NOTICE OF DETERMINATION

PL22-0111 a Plot Plan Application and Grading Exemption to construct a 88,390 SF industrial building
 Project Title/Case No.

2001121065	City of Escondido
State Clearinghouse Number (if submitted to State Clearinghouse)	Lead Agency

Figure 3

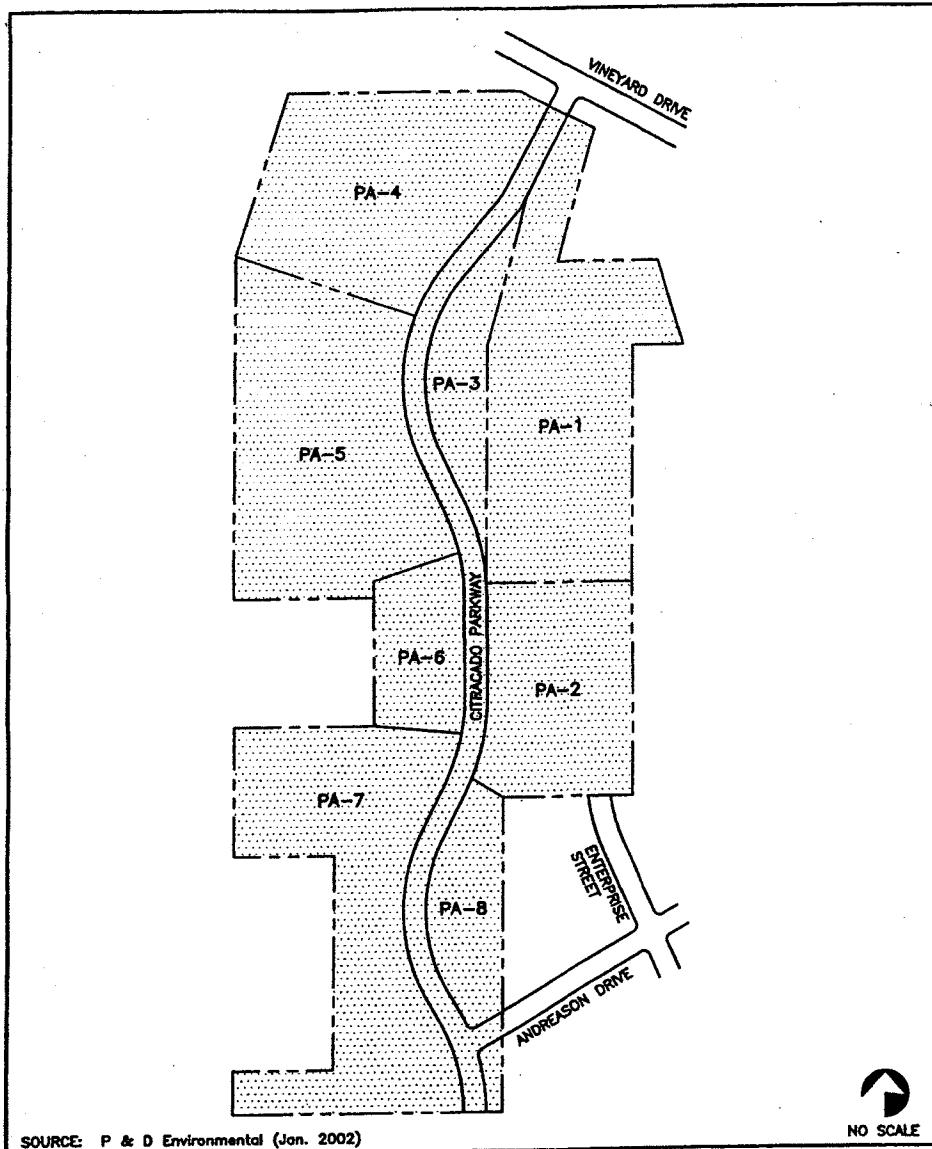
- SDCO-4 • The Harmony Grove Road/Andreason Drive corridor is depicted as a through/continuous route in the County's and the City's General Plan Circulation Element. The proposed project, as shown in the Conceptual Site Plan (Figure 3, Pg.5) necessitates an offset (see attachments) of the Harmony Grove Road/Andreason Drive corridor. The realignment of Harmony Grove Road and Andreason Drive should be included in the project description. The TIA should fully assess any on-site and/or off-site impacts that would result from the realignment of the Harmony Grove Road/Andreason Drive corridor.

Figure S-2

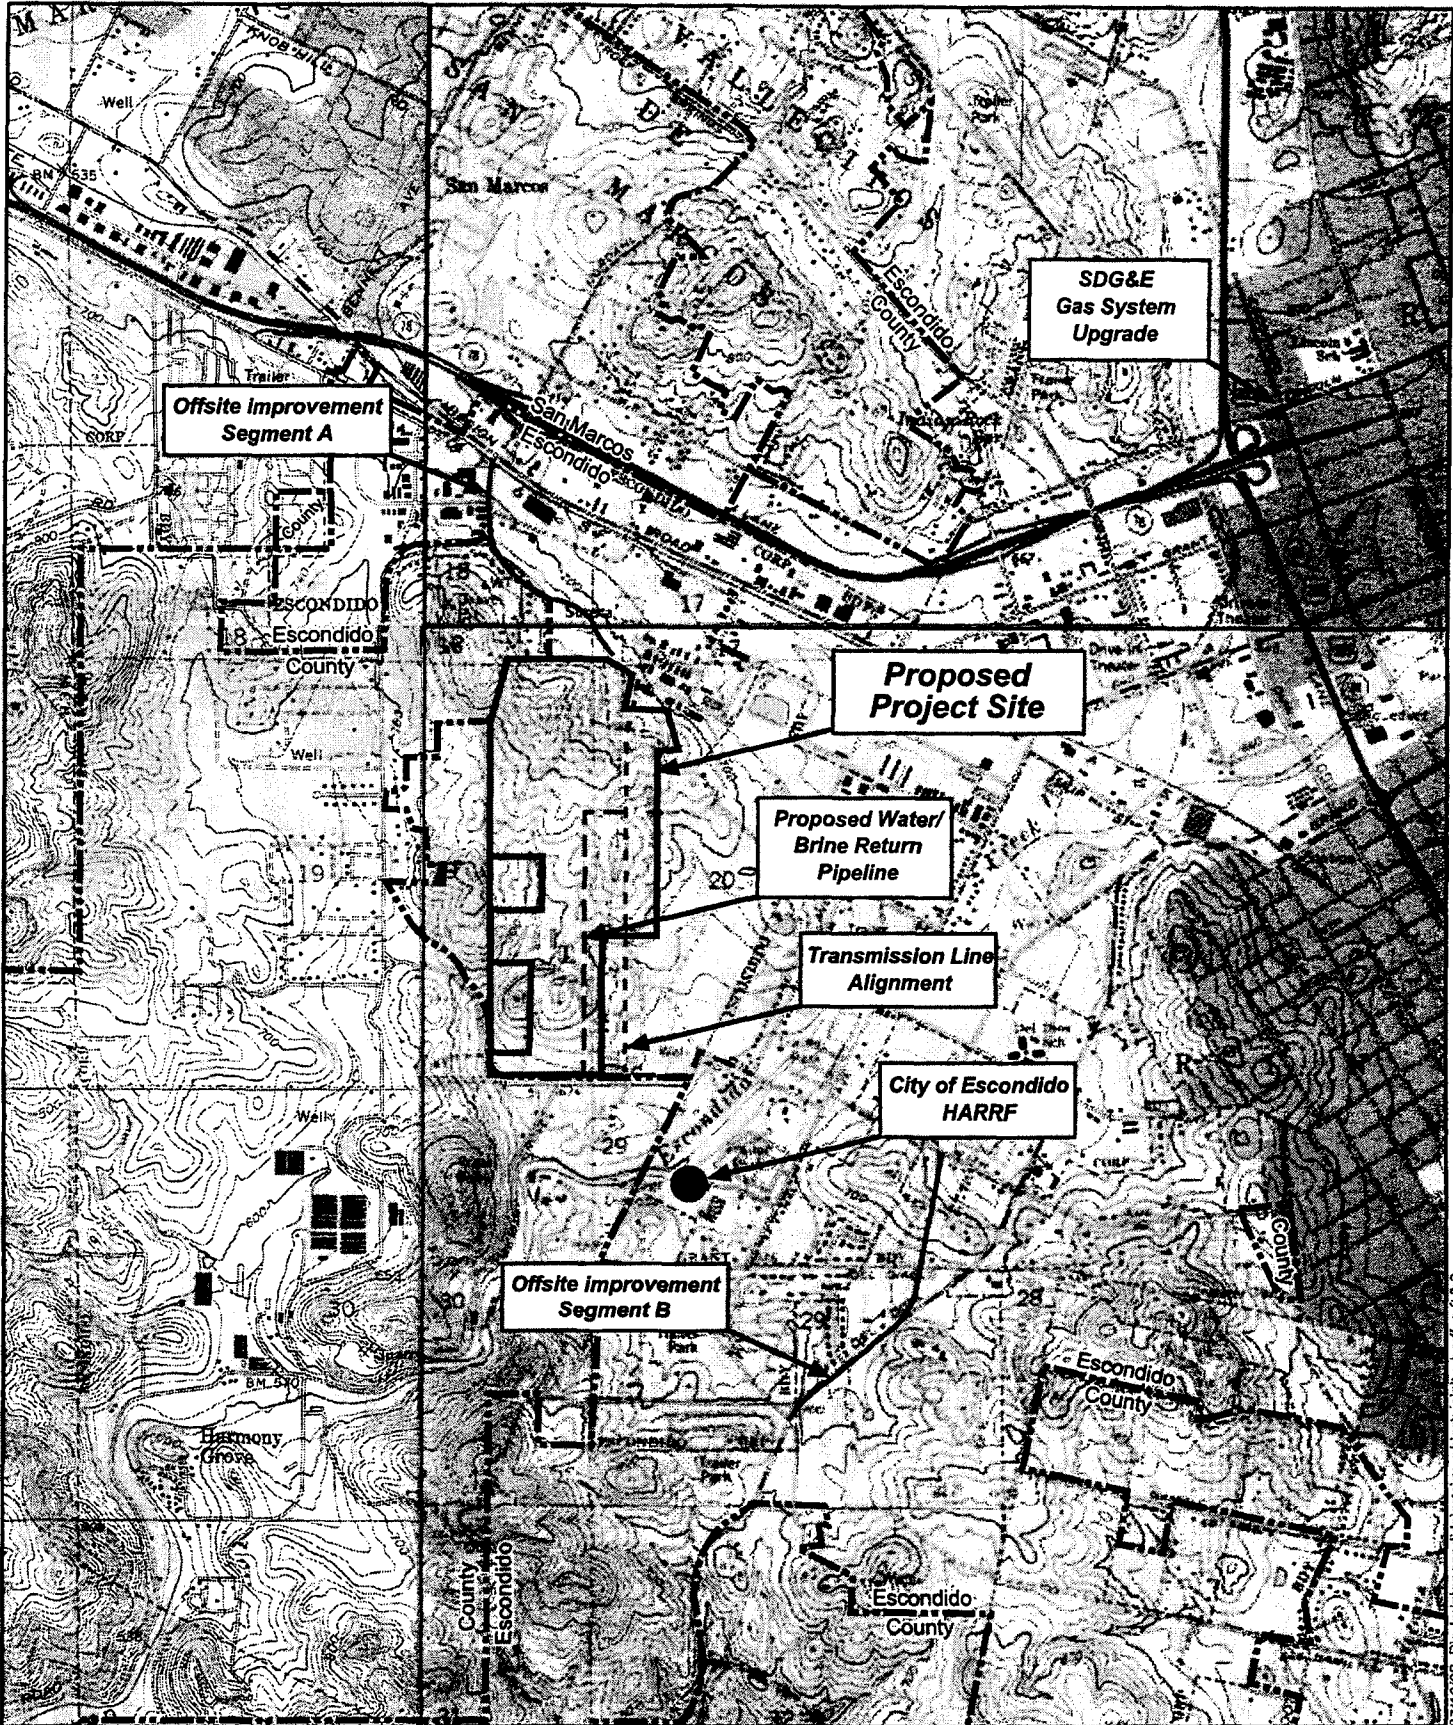
1. Comments Related to the Transmission Facility Work as Part of the ERTC Project		
Section	Location	Recommendation
<i>(Executive Summary)</i>		
SDGE-3	<i>Figure S-2 (Vicinity Map)</i>	The figure should also show and label the existing SDG&E transmission right-of-way (ROW).
SDGE-4	<i>Page S-4, 2nd Paragraph</i>	The 5 th sentence should be reworded as follows: "A 200-foot wide electrical transmission easement, containing two 230kV circuits and one 138kV circuit on steel lattice tower structures, and five 69kV circuits on wood pole structures bisect the eastern and western portions of the SPA."
SDGE-5	<i>Figure S-3 (Conceptual Site Plan)</i>	The figure should label the existing transmission ROW shown by the dashed line.
SDGE-6	<i>Figure S-4 (Proposed ERTC Land Use)</i>	The figure should show and label the existing transmission ROW.
SDGE-7	<i>Page S-8, Planning Area 1</i>	Replace the 4 th sentence with the following: "As part of the electrical interconnection process of the power plant's new 230kV switchyard, existing 230 kV and 138 kV transmission lines located within the existing 200-foot wide right-of-way will be realigned to position the existing 230 kV line closer to the eastern edge of the right-of-way."

- SDG&E-3 Figure S-2 has been modified to include the SDG&E transmission right-of-way (ROW).
- SDG&E-4 The text has been modified to provide a more detailed description of the existing SDG&E transmission lines on the project site. The requested text has been added as follows: "A 200-foot-wide electrical transmission easement, containing two 230-kV circuits and one 138-kV circuit on lattice tower structures, and five 69-kV circuits on wood pole structures bisect the eastern and western portions of the SPA."

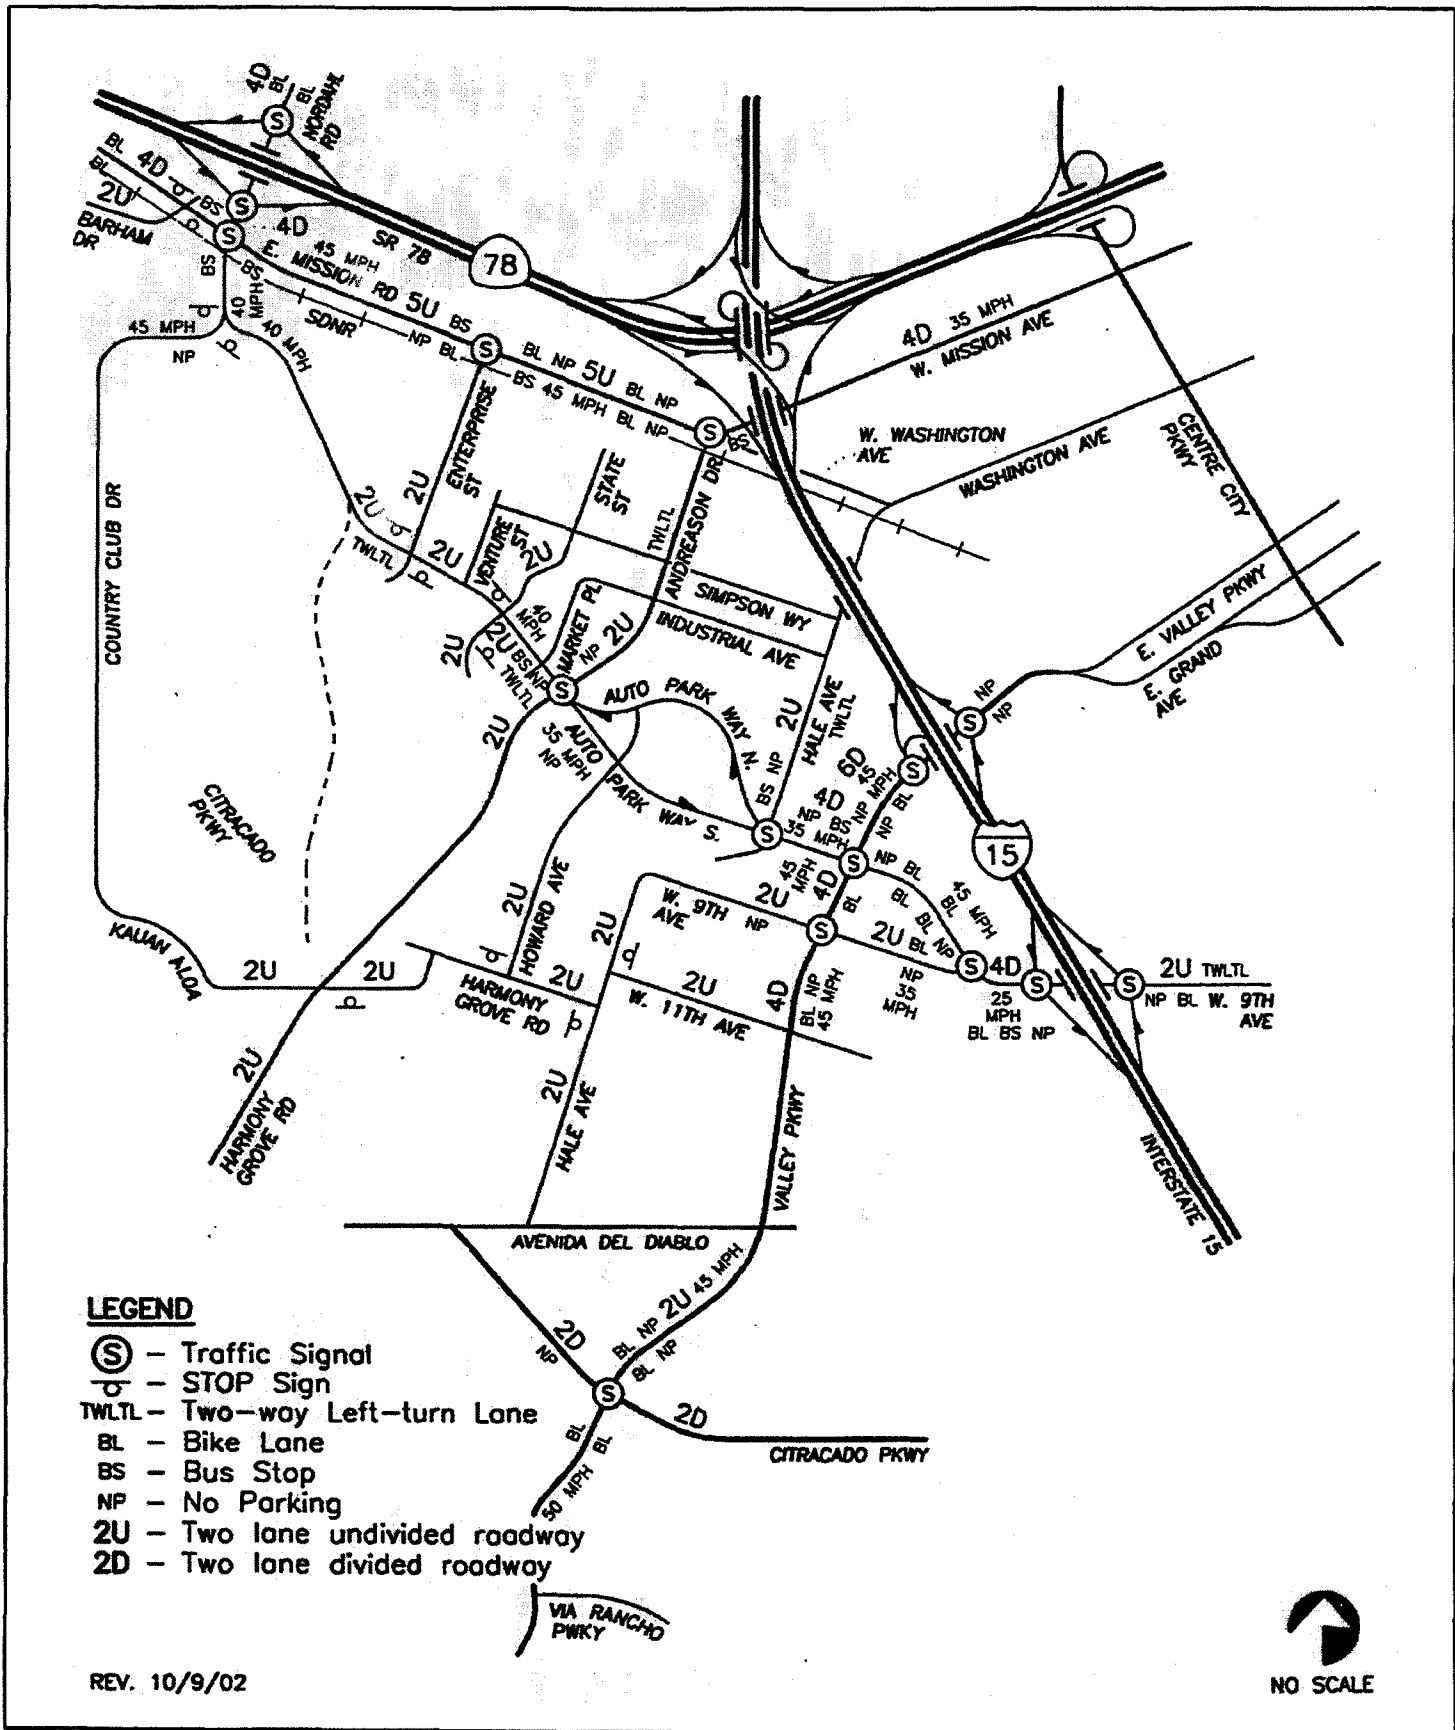
- EF-1 The Elfin Forest / Harmony Grove Town Council appreciates the opportunity to review the above referenced EIR. We request that a correction be made to the EIR to reflect the barricading of the southeast portion of Citracado Parkway just past the intersection with Andreasen, as promised by Homi Namdari, Asst. City Engineer, at a meeting held August 28, 2002, with Escondido city staff members including yourself and representatives of local civic groups. We suggest correction to, inter alia, the figures depicting projected traffic distributions (Figure 2.2-3, 2.2-7, 2.2-8, and 2.2-9). In addition, the sentence about a southern access point to the project via Citracado Road (page 2.2-3) should be deleted.

- EF-1 The Final EIR has been revised to clarify that the proposed project will extend Citracado Parkway southward to Andreasen Drive. Please refer to Section 2.2 for revised Figures 2.2-1, 3, 5, 6, and 7.

- HG-1 The Final EIR has been revised to clarify that the proposed project will extend Citracado Parkway southward to Andreason Drive. Please refer to Section 2.2 for revised Figures 2.2-1, 3, 5, 6, and 7.

SDPG-1 The EIR will be revised to clarify that the project will extend Citracado Parkway southward to Andreasen Drive. Figures 2.2-1, 3, 5, 6, and 7 have been revised. The connection of Citracado Parkway and Harmony Grove Road is not proposed.

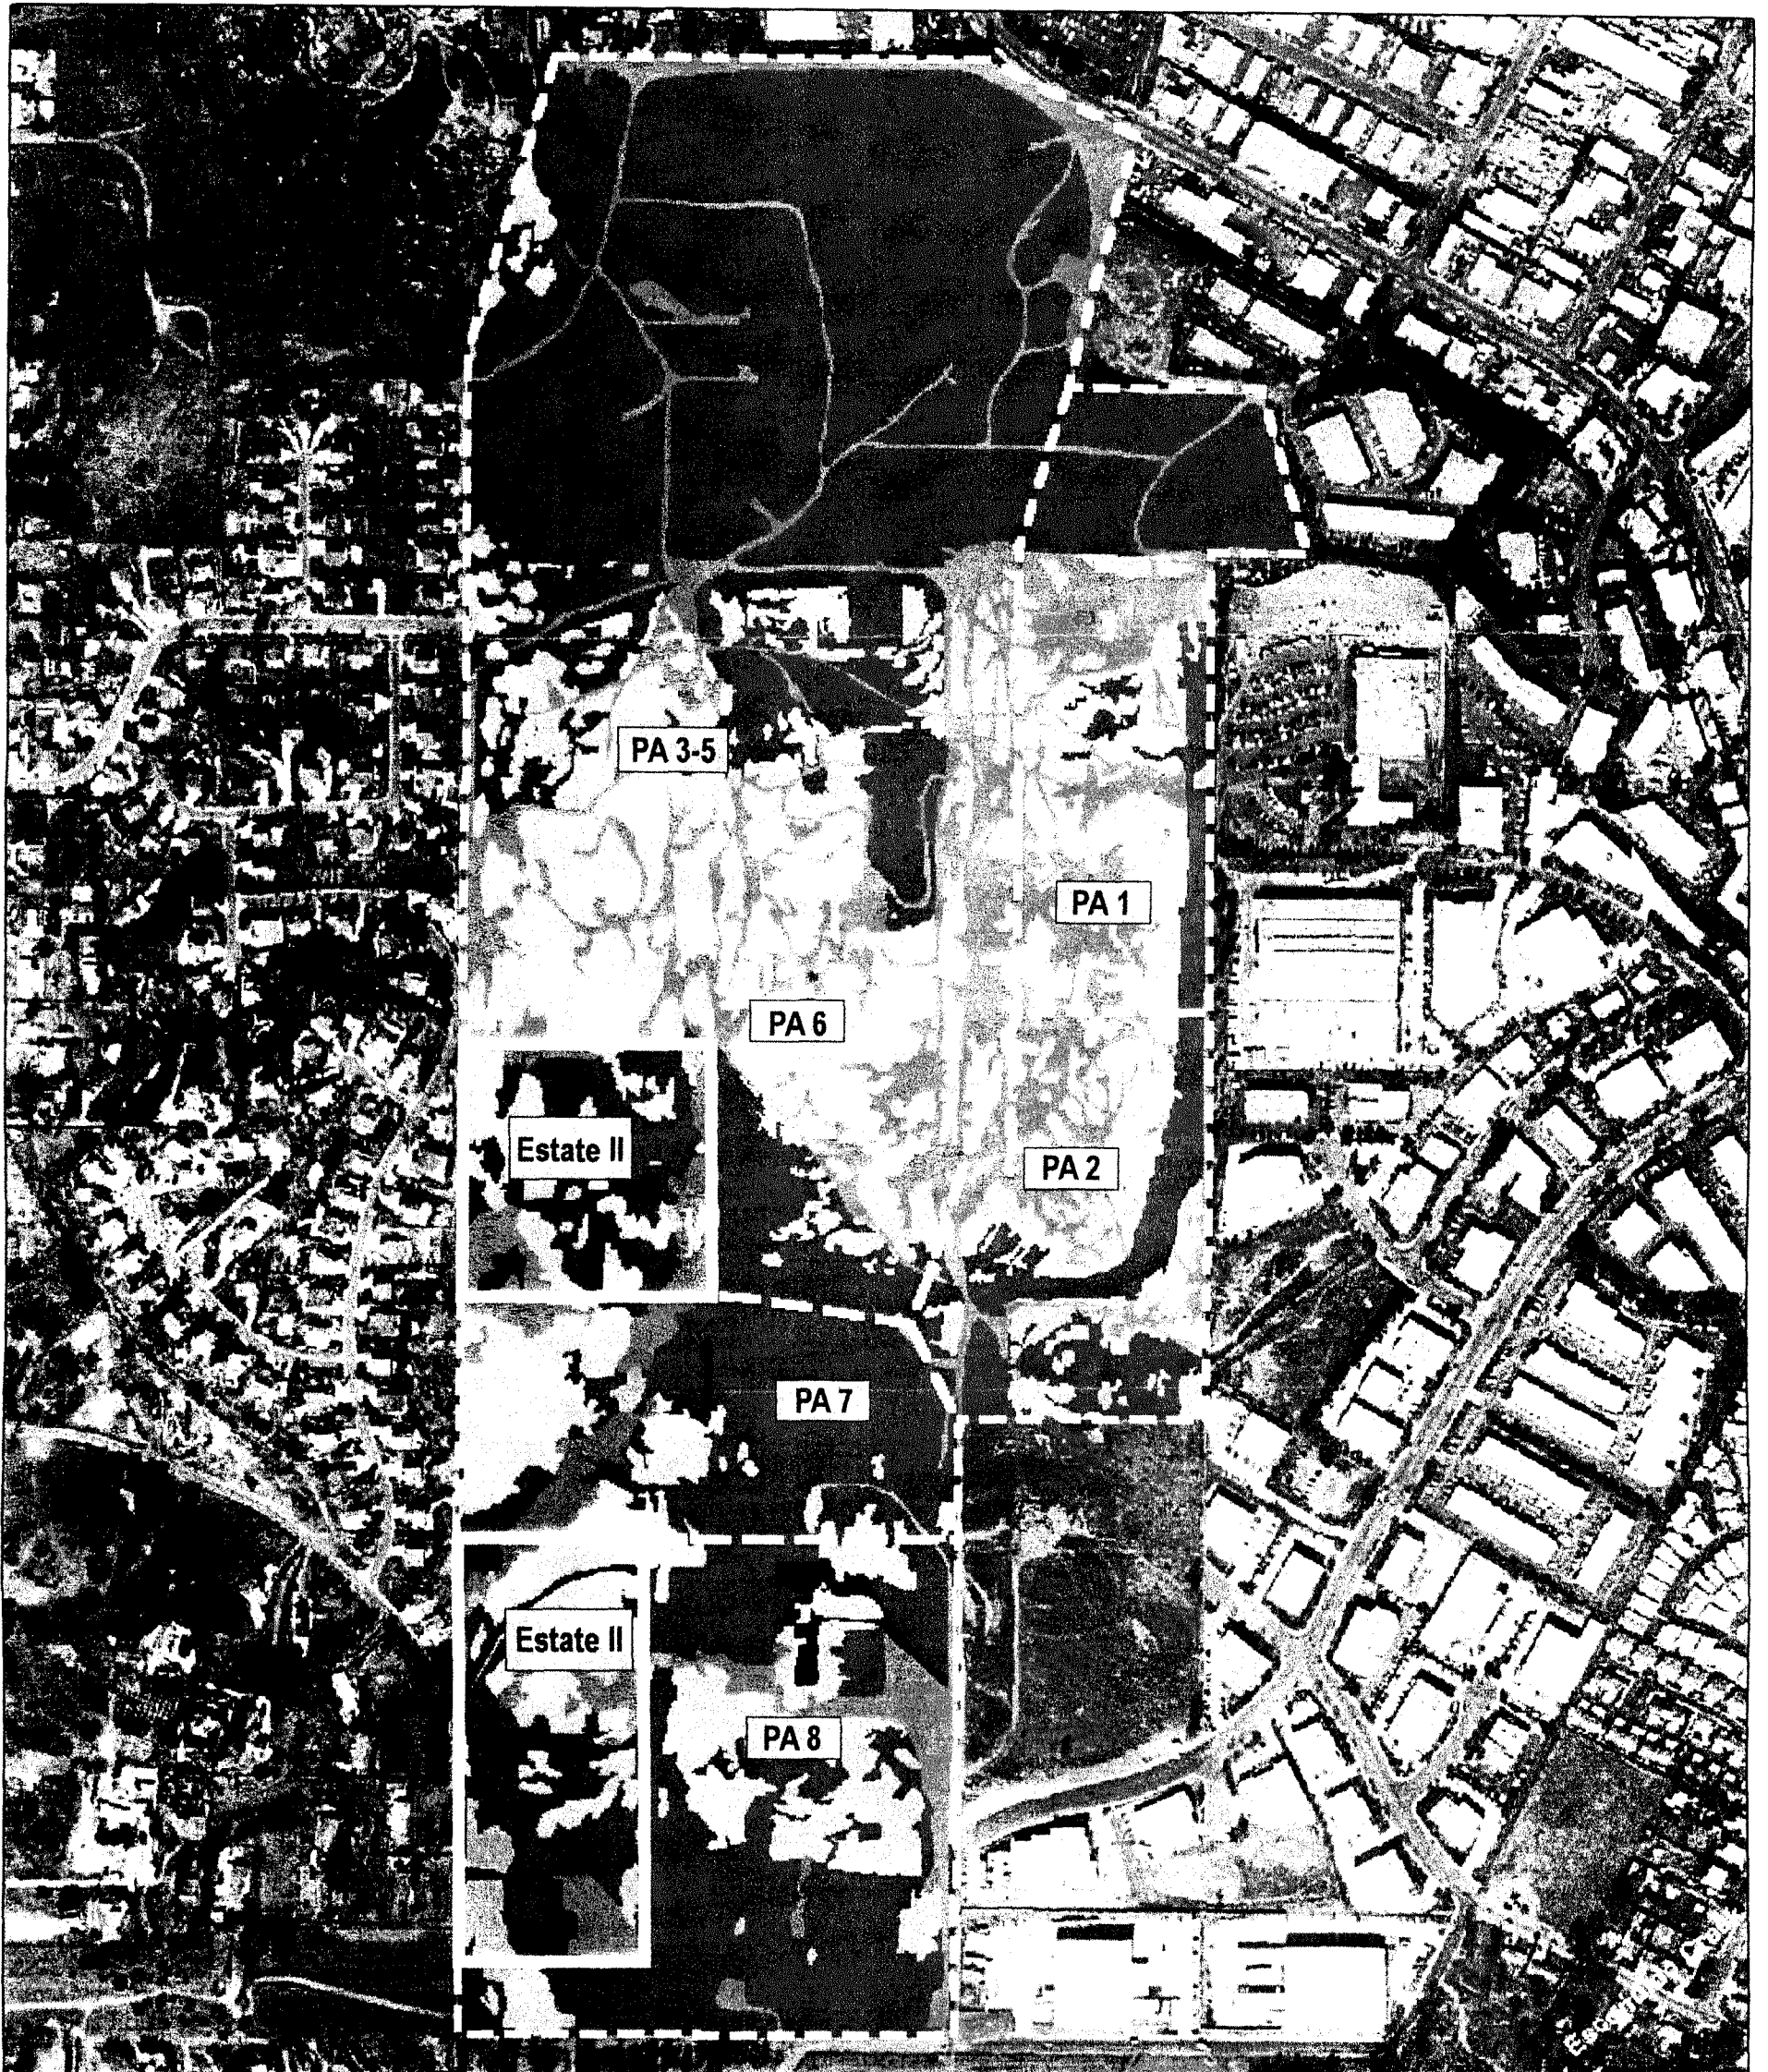
- CEC-20 Figure 2.6-1 shows the biological resources identified on the project site. The comment indicates support for the revised biological resources map for the project site showing nonnative grasslands at the north end of the project site. The comment has been noted; no changes have been made to the EIR.

- CEC-21 Figure 2.6-1 was obtained from the Biological Resources and Impact Assessment prepared by Merkel and Associates. This graphic was updated and revised in February 2002 and incorporated into the DEIR. Appendices E and F detail the survey methodology used in identifying and mapping biological resources onsite. The text and graphics have not been changed in the Final EIR.
